Safety Evaluation Report

Renewal of the Facility Operating License for the
Armed Forces Radiobiology Research Institute
TRIGA Reactor

License No. R-84
Docket No. 50-170

U.S. Nuclear Regulatory Commission

Figure 2-2 The AFRR I TRIGA RELAP5 model

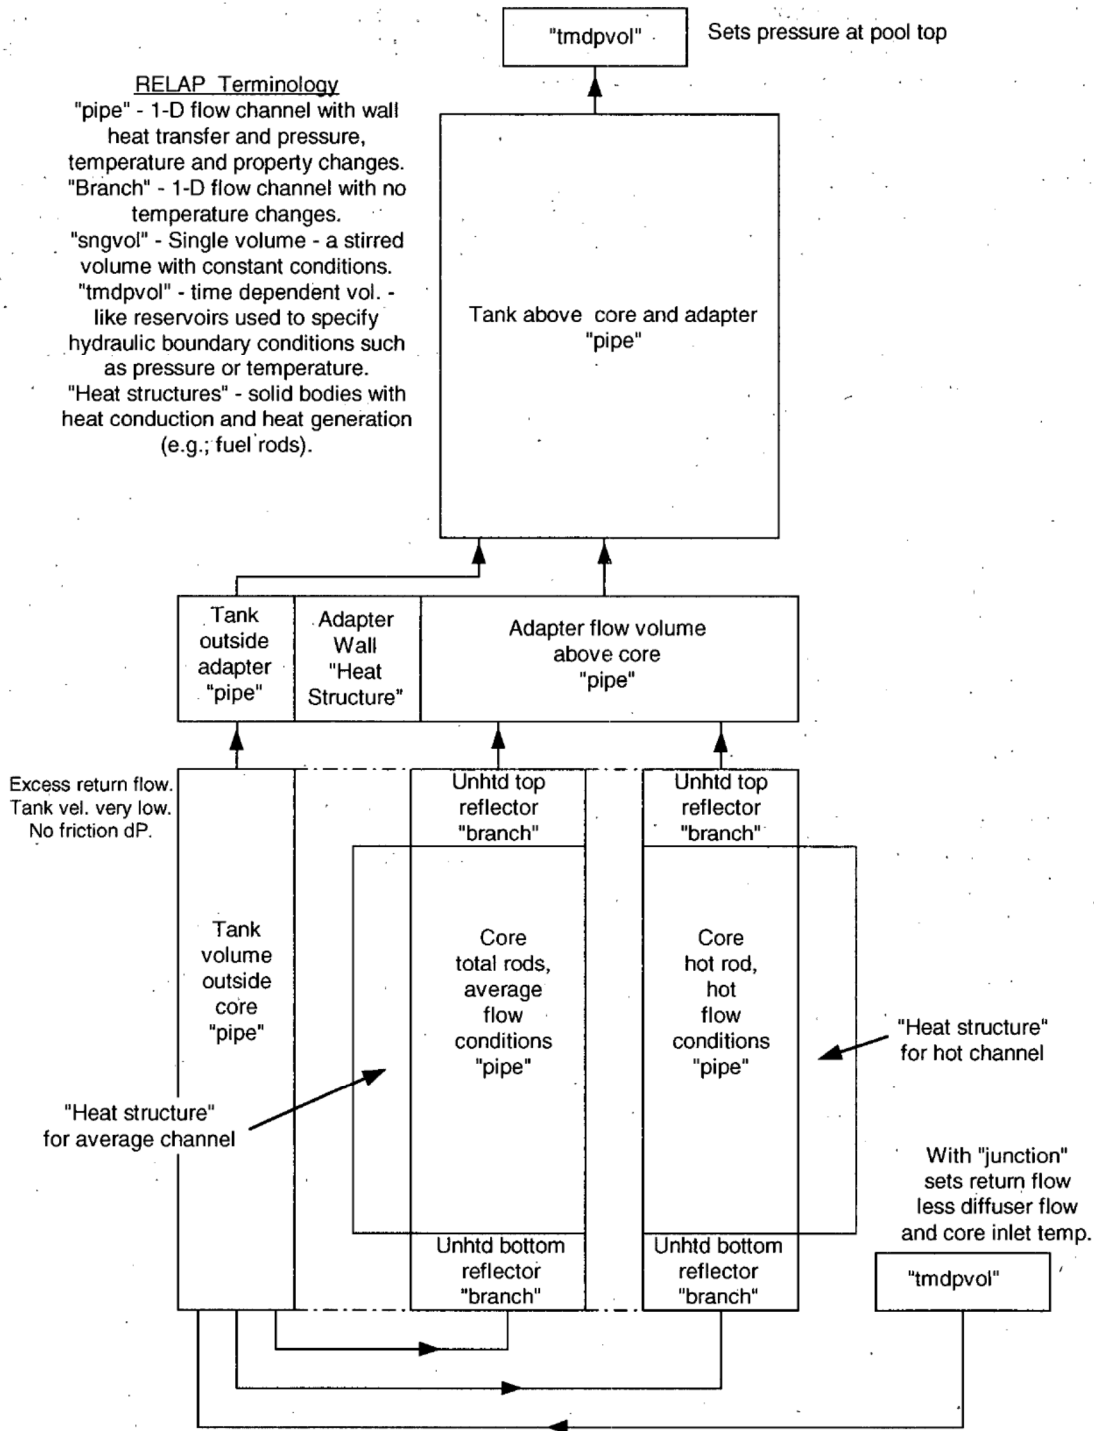
The licensee presented an analysis of the AFRR1 TRIGA DNBR using the Reactor Excursion and Leak Analysis Program 5 (RELAP5)-3D (Ref. 2). The methodology and computer codes used for this analysis have been compared to actual measurements and consistently produce conservative results. The NRC staff considers the use of RELAP5 with the Bernath correlation to determine the critical heat flux (and thus departure from nucleate boiling) to provide a best estimate analysis of DNBR. The licensee's thermal-hydraulic design report describes the basic features of the licensee-supplied model used in its analysis. Figure 2-2, reproduced from that report, illustrates the basic features of the model, which includes a hot channel with its associated coolant and heat structure (the hot fuel element). There is also an average channel that represents the remaining fuel, fuel followers, and the associated coolant inside the reactor core. The channels are connected to a riser section that directs the coolant flow away from the top of reactor core into the reactor tank and then into the downcomer structure. The returning flow is directed into the reactor core near the bottom of the reactor tank.

The model assumes that there is no crossflow between adjacent channels. This assumption is conservative because higher values of temperature and lower margins to the DNBR are typically predicted when crossflow between adjacent channels is ignored. RELAP5-3D is used to calculate the steady-state natural circulation flow through the water channels adjacent to the fuel elements. The code also calculates all radial heat transfer from the fuel element into its associated coolant channel. Accordingly, the code calculates the cladding and fuel axial and radial temperature distributions as well as the axial temperature distribution in each coolant channel.

The RELAP5 model used by the licensee is based on a circular arrangement of fuel elements. The model also includes a representation for the shroud, which extends 5 feet (1.5 meters) from the core top grid plate. The water exiting the top of the core shroud enters the reactor pool water. The pressure at the top of the reactor core is sum of atmospheric pressure at top of the pool plus the hydrostatic pressure associated with the water column above the core at this elevation. The core height plus the adapter height provide the buoyancy head for natural circulation of water inside the reactor tank and the core region.

Figure 2-4 The 85-3 core loading

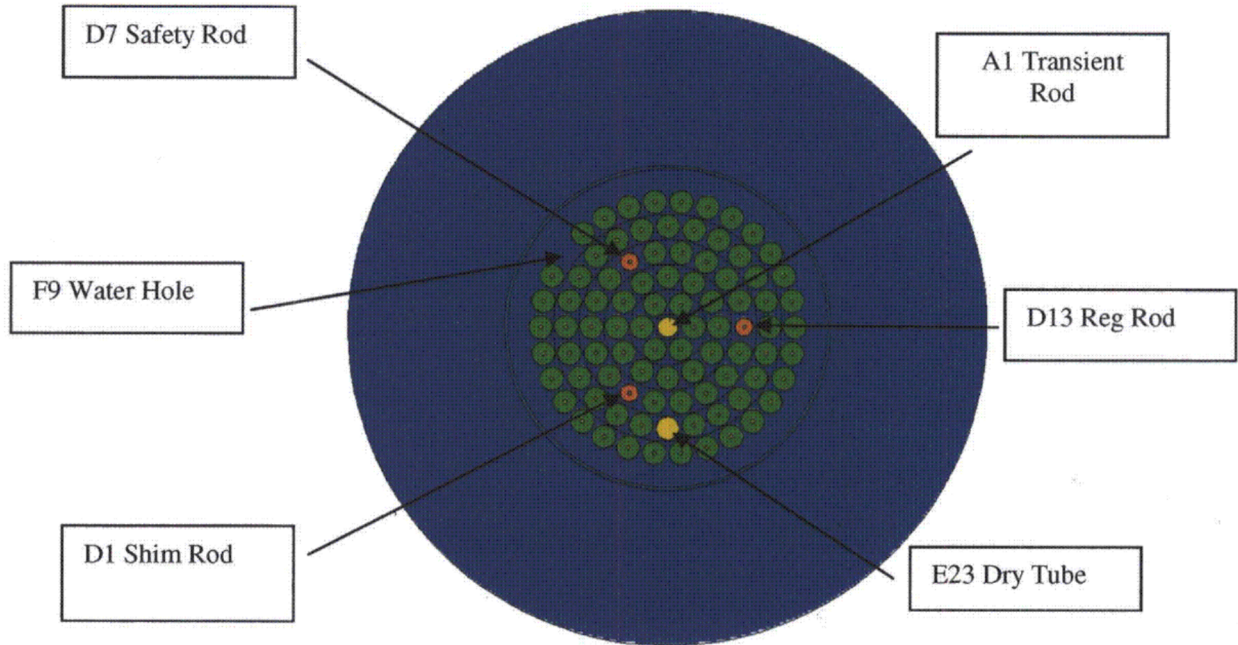
The licensee calculated the hot channel geometry as follows (see Figure 2-4):

The tri-cusp area between the core center rod, A-1, and two adjacent B ring rods forms the minimum flow area in the core and includes the maximum power rod. The three rods that form this tri-cusp flow area constitute one-half of a rod. Additionally, the heated perimeter for this flow area represents only one-third of a rod because the central location A-1 is not a fuel rod. Customarily, this area is doubled to represent the flow area and hydraulic diameter for a whole rod. The flow area then represents two-thirds of a heated rod. Input to RELAP5 for the "maximum rod" is two-thirds of a rod surface area and two-thirds of the hot rod power.

Although it is true that the central thimble provides no power for the cell described, this is the limiting channel to consider for the DNBR analysis (Figure 2-5). Scaling the flow area and power to a full fuel element shows that this channel is more limiting than the channels with more fuel elements. This is further discussed below in Section 2.6.1 of this SER under "Confirmatory Analysis."

Figure 2-6 AFRRI models used by the NRC for confirmatory TRACE and RELAP5 analysis

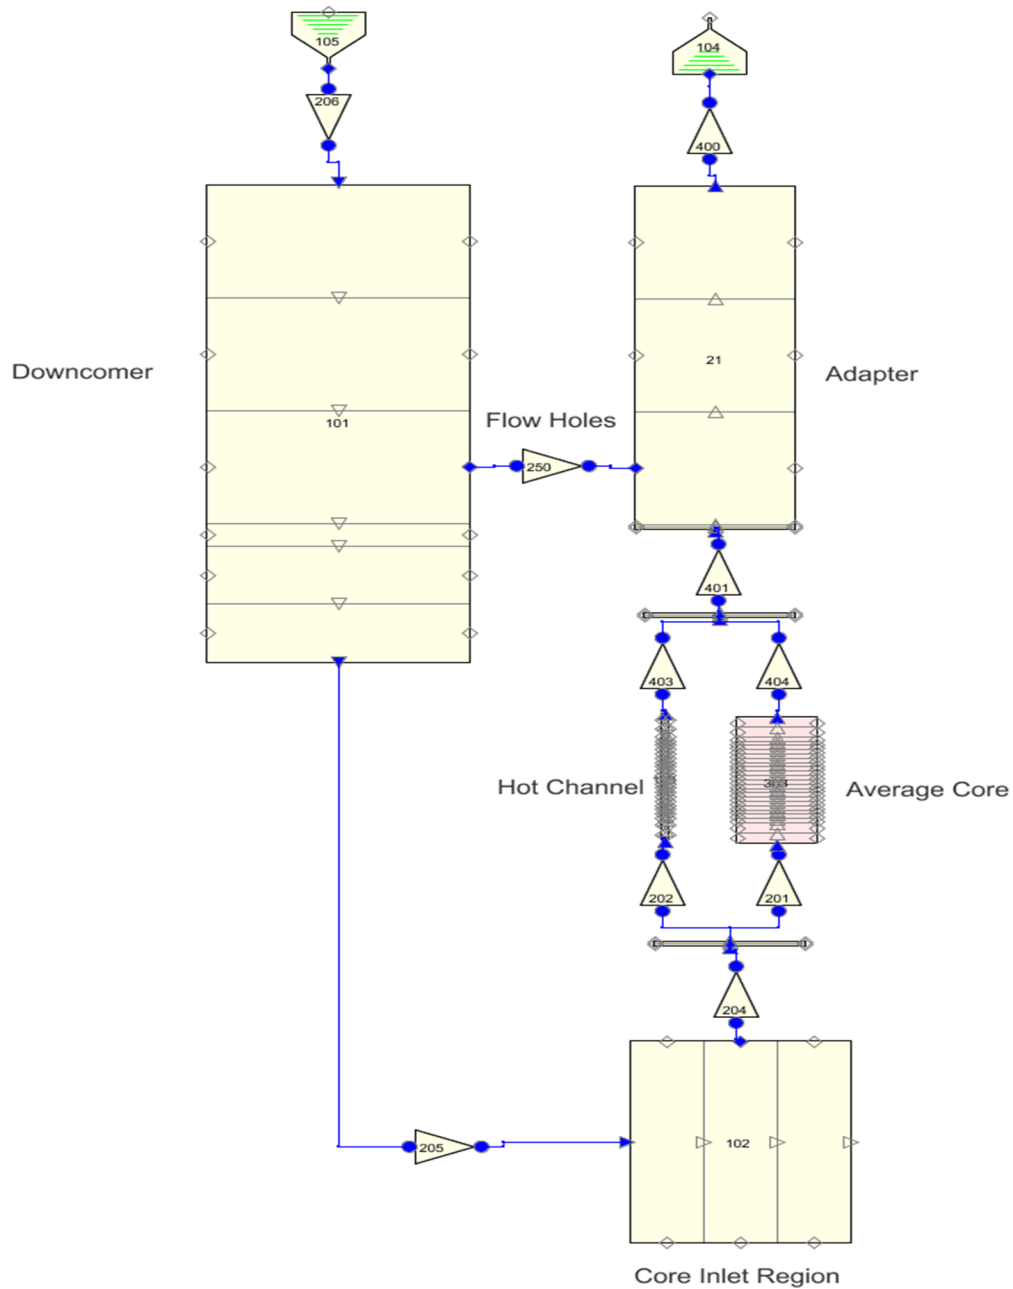
The NRC confirmatory calculations used both the TRACE and RELAP5/MOD3.3 computer codes to represent the AFRRRI reactor's thermal-hydraulic behavior using components that represent the major features, such as the reactor core, the downcomer, and the core adapter region that acts as a chimney above the core and enhances natural circulation. This analyses use a one-dimensional noninteracting representation of a hot and an average channel (i.e., N-1 channel) inside the core based on RELAP5 and TRACE "PIPE" components (hereafter referred to as the "pipe model"), as shown in Figure 2-6.

One difference in the NRC model from the licensee model is that the flow holes connecting the downcomer to the adapter are modeled. These flow holes allow cold water from the downcomer region to enter into the adapter chimney flow, which reduces the buoyancy head of the natural circulation flow system.

Figure 2-7 Fuel element diagram for rings A–C drawn to scale

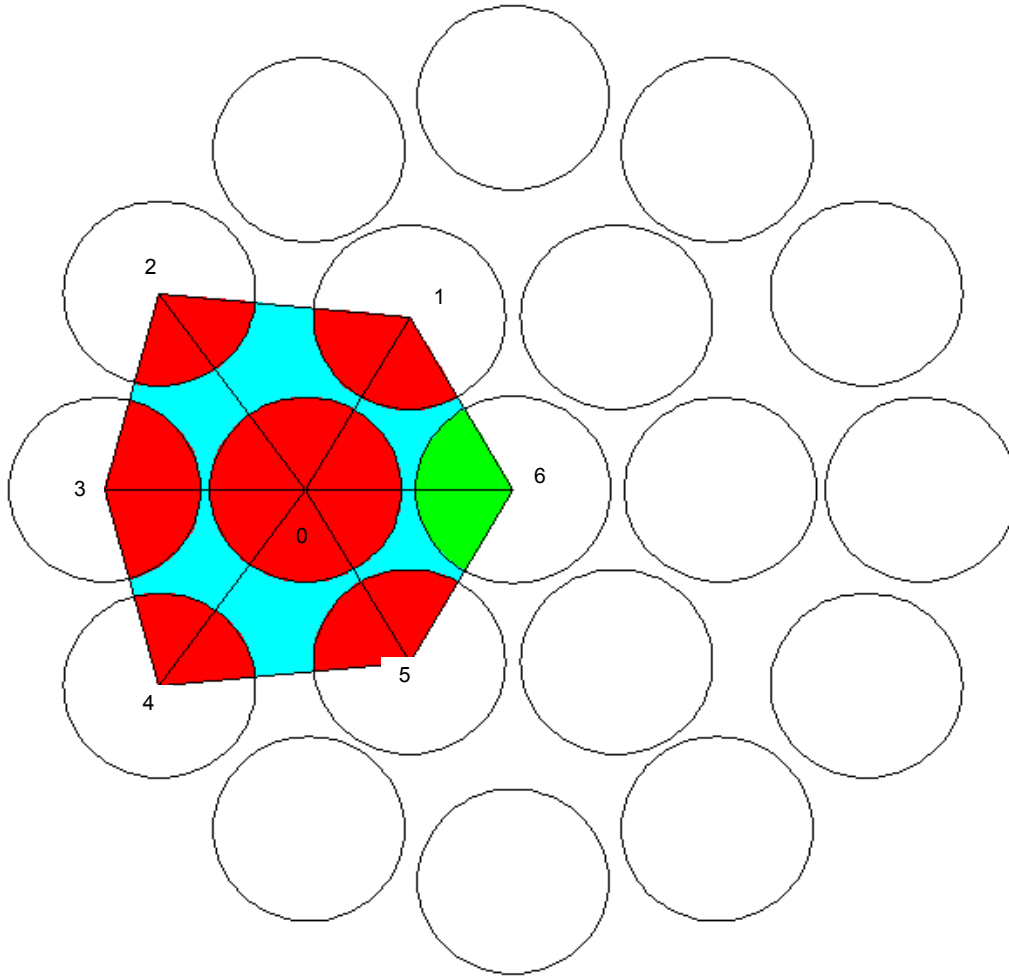
Because the AFRRI reactor hot channel is somewhat irregular, it can be represented using six triangles (see Figure 2-7). Each of these triangles creates a unique thermal-hydraulic region contributing to the hot fuel element. By using the coordinates from the AFRRI reactor core plate and the correct geometry of the fuel pin and guide thimbles, it is possible to accurately calculate the flow area of each triangle. Three pairs of identical triangles are then determined. Each triangle then represents half of the flow area for a full fuel element. The doubled (full fuel element) flow areas are 3.051, 4.60, and 7.05 cm².

Figure 2-7 shows that this forms six triangles that have the associated flow areas listed in Table 2-4.

The triangles having heated fuel elements on each the vertices are the 0-2-3 and the 0-3-4 triangles. The hydraulic diameter associated with the representation in Figure 2-7 is 1.56 cm. The hot fuel element power of 19.6 kWt is used with a constant inlet temperature of 60 °C (140 °F) (i.e., the limiting value).
